SERVICE INFORMATION NO. SI36-056

ATA Code: 34
GARMIN Service Bulletin No. 0921 Rev. B

****MANDATORY****
SERVICE BULLETIN
NO.: 0921 Rev B

TO: All Garmin Aviation Service Centers
DATE: July 13, 2009
SUBJECT: SL30, SL40, GNS 480 (CNX80) Comm Radio Spurious Emissions

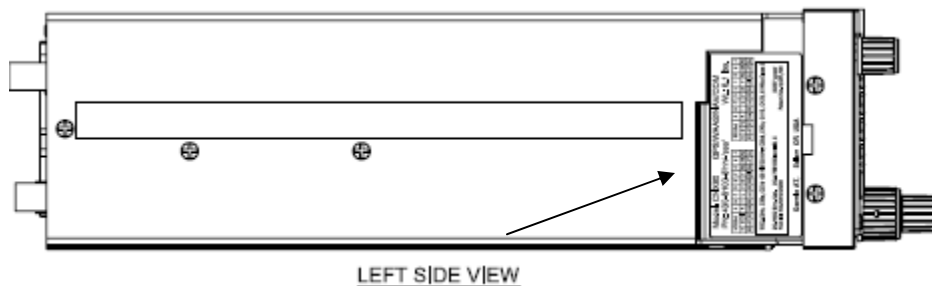
MOD LEVEL IDENTIFICATION INSTRUCTIONS:

To identify the mod level of a GNS 480 (CNX80) unit:

Remove the unit and locate the nameplate on the left side of the unit. The hardware mod status is indicated in the block on the left side of the nameplate.

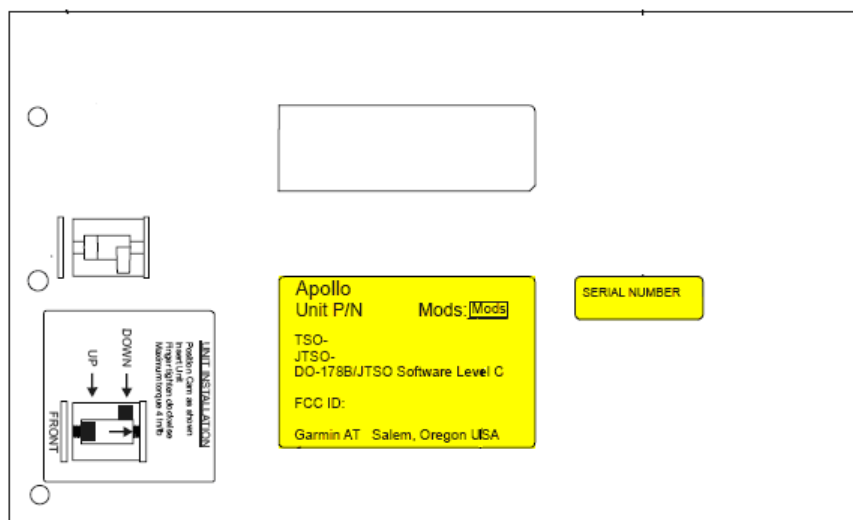
To identify the mod level of an SL30 or SL40 unit:

Remove the unit from the aircraft and locate the nameplate on the bottom side of the unit.
